# Access Compliance Report

## Public Rights-of-Way (Curb Ramps)

Intersection ID: 42753	Main Street: WATTS_BLUFF_DR	Cross Street: ASHLEY_MEADOW_DR	Location: E
ADA ID: B041159462C9	Ramp Type: BlendTrans1	Initial Pass/Fail: Fail	Overall Compliance: No
Severity Score: 8.75			
Codes/Mitigation Info/Possible Solution		Field Measurements/Component Compliance

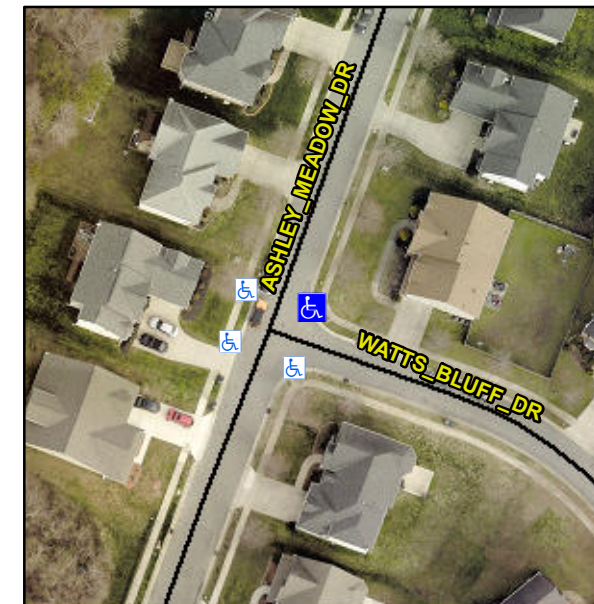
**R304.5.1**

Compliance	Description	Data	Compliance	Description	Data
N/A	Ramp Length (in)	48.0	Yes	BlendTrans Slope (%)	4.6
No	Ramp Width (in)	41.5	Yes	BlendTrans XSlope (%)	0.5
N/A	Flare Type LT	N/A	N/A	Flare Type RT	N/A
N/A	Flare Slope LT (%)	N/A	N/A	Flare Slope RT (%)	N/A
N/A	Flare Traversable LT?	N/A	N/A	Flare Traversable RT?	N/A
N/A	Landing Length (in)	N/A	N/A	DWS Provided?	N/A
N/A	Landing Width (in)	N/A	N/A	DWS Contrast?	N/A
N/A	Landing Slope (%)	N/A	N/A	DWS Length (in)	N/A
N/A	Landing X Slope (%)	N/A	N/A	DWS Full Width?	N/A
N/A	Landing Curb? (Y/N)	N/A	N/A	DWS Offset (in)	N/A
N/A	Shared Landing?	N/A			
N/A	Gutter Ponding?	N/A	N/A	Gutter Slope (%)	N/A
N/A	Gutter Lip Ht (in)	N/A	N/A	Gutter X Slope (%)	N/A
N/A	Painted X Walk1?	No	N/A	Painted X Walk2?	No
	X Walk 1 Direction	To N		X Walk 2 Direction	To S
	X Walk 1 Width (in)	N/A		X Walk 2 Width (in)	N/A
	X Walk 1 Slope (%)	1.7		X Walk 2 Slope (%)	1.0
	X Walk 1 X Slope (%)	0.0		X Walk 2 X Slope (%)	0.4

**Remove & Replace Curb Ramp With Two New Directional Ramps or Equivalent.**
